Addendum No.: 1

Bid#: 24-10-2

Project Name: Highway LA-21 Lift Station

WET WELL ELEVATION
N.T.S.

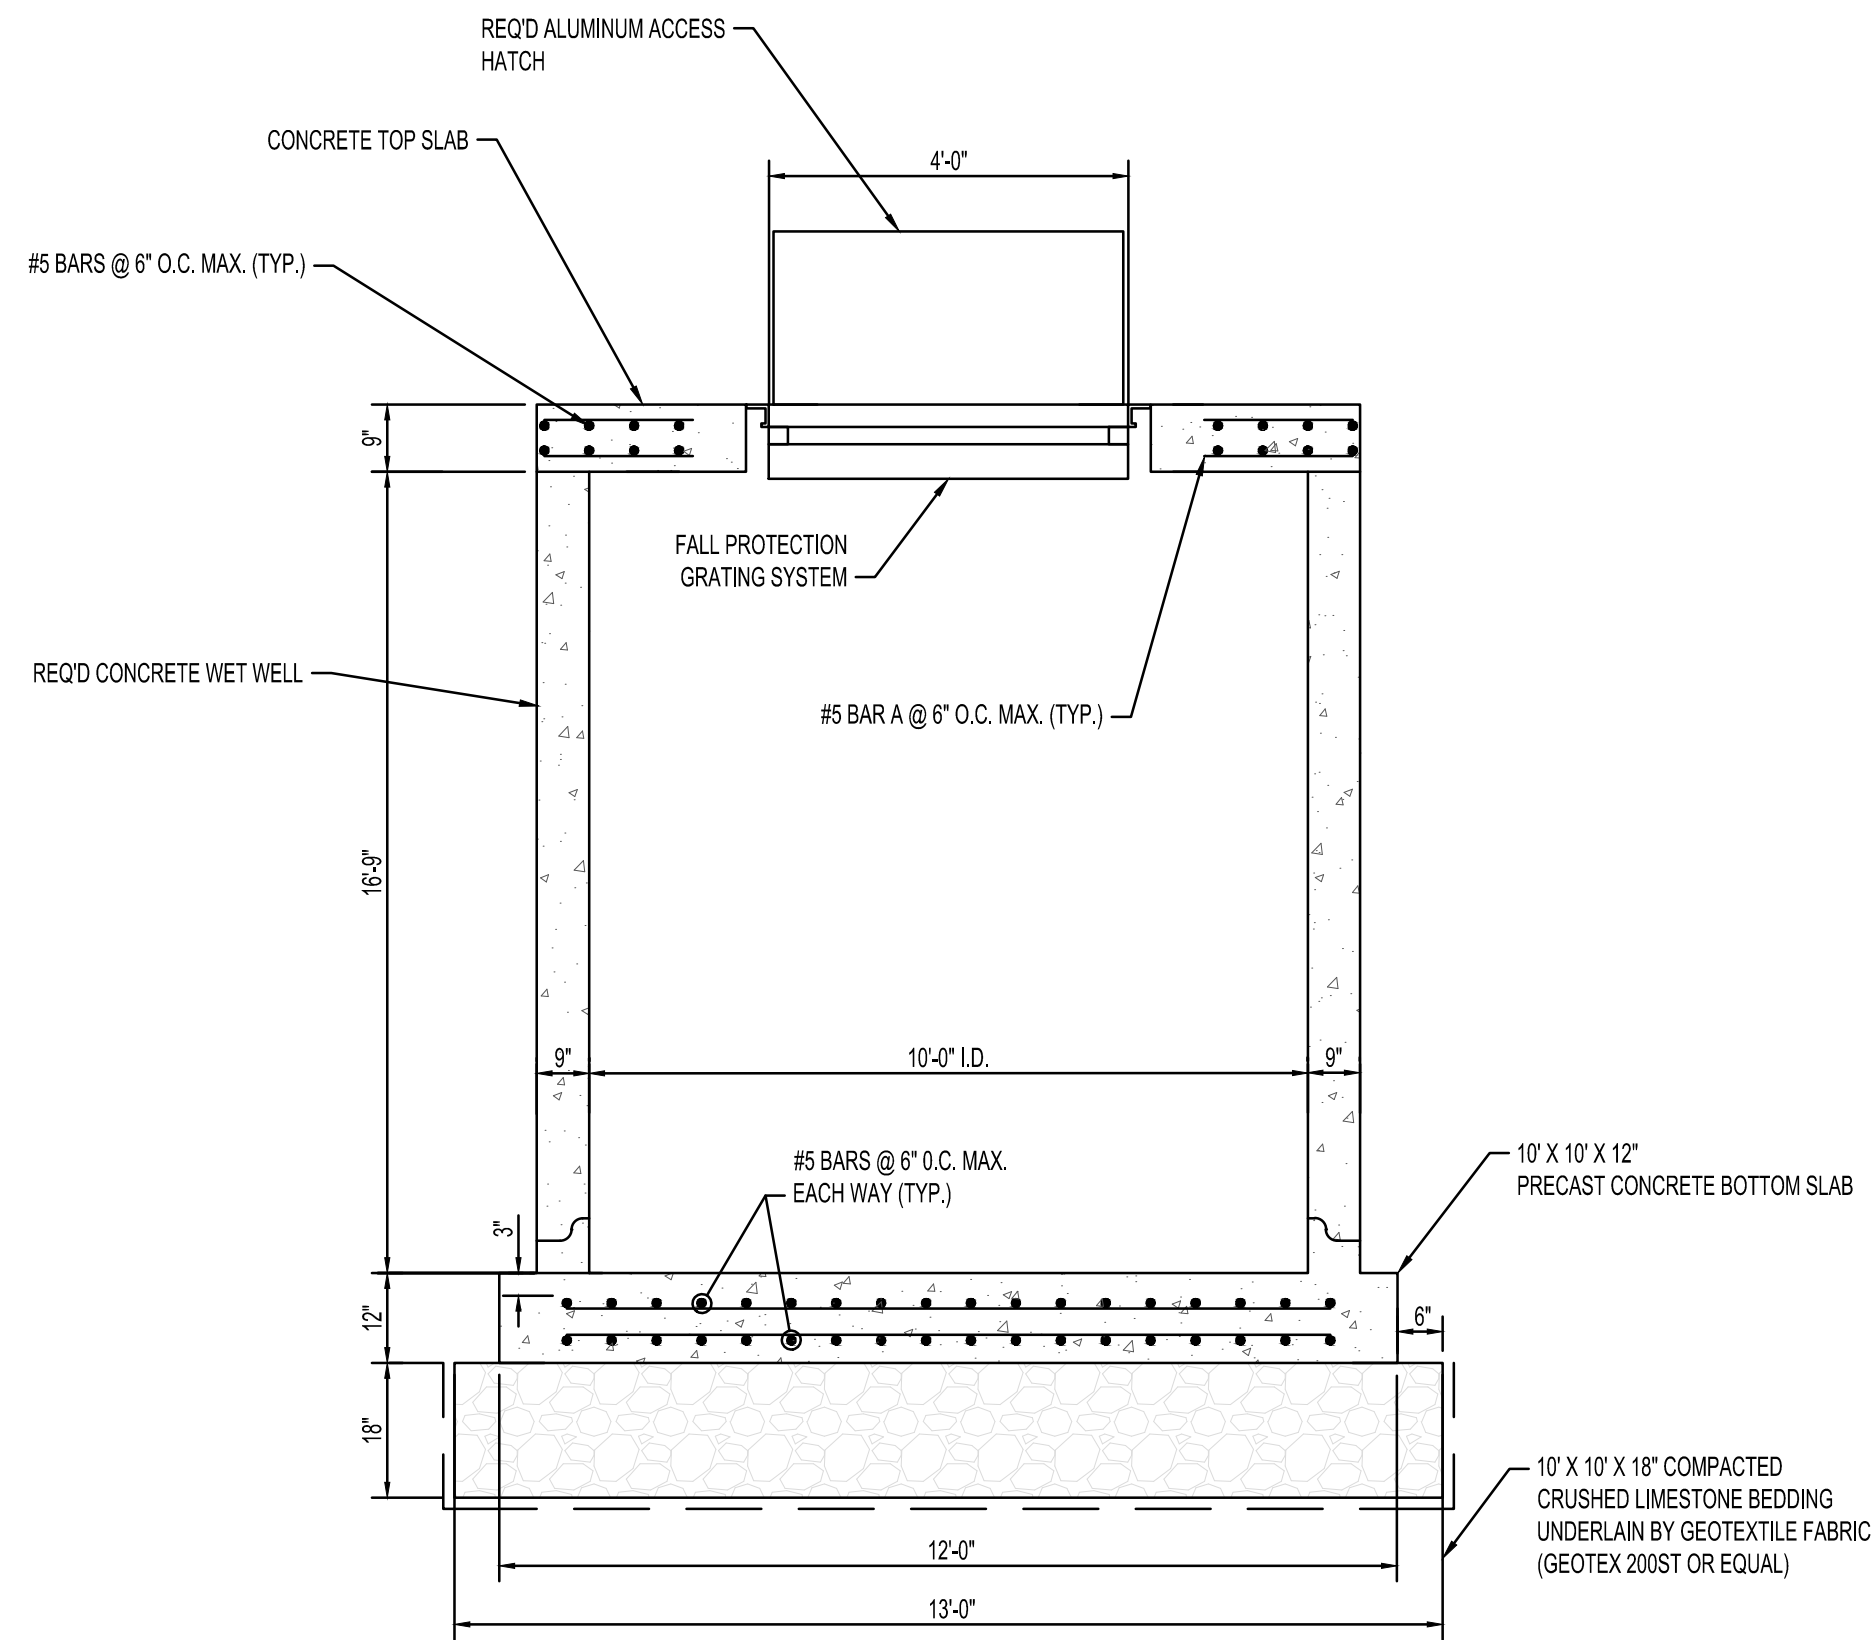
- Question 6:** Can a spec be provided for allowable backfill material for the wet well?
Answer 6: Required backfill material shall be Compacted Granular Material (River Sand), min. density 95% Standard Proctor (ASTM D698), placed in 12” max. layers. The Excavation and Backfill requirements apply per Section 02300. Work and backfill shall be included under Item No. 116 – 10’ I.D. Concrete Wet Well. See Note 11 under the ‘Notes’ on Sheet 12 – Lift Station Plan and Elevation in this Addendum below.

4. Sheet 12 – Lift Station Plan and Elevation

- Add Note 11 to ‘Notes’:

“Required backfill material shall be Compacted Granular Material (River Sand), min. density 95% Standard Proctor (ASTM D698), placed in 12" max. layers. The Excavation and Backfill requirements apply per Section 02300. Work and backfill shall be included under Item No. 116 – 10’ I.D. Concrete Wet Well.”

PAVEMENT NOTES (ALL SECTIONS):

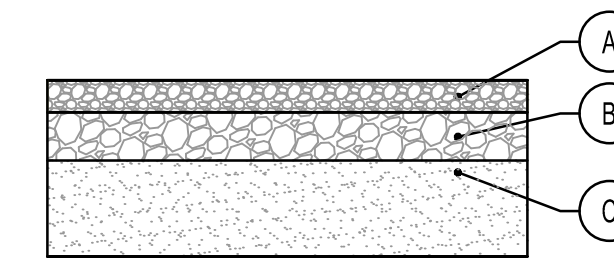
5. Sheet 13 – Details:

- Revise date of referenced geotechnical report under ‘PAVEMENT NOTES (ALL SECTIONS):

Change from ‘8/11/2023’ to ‘8/14/2023’
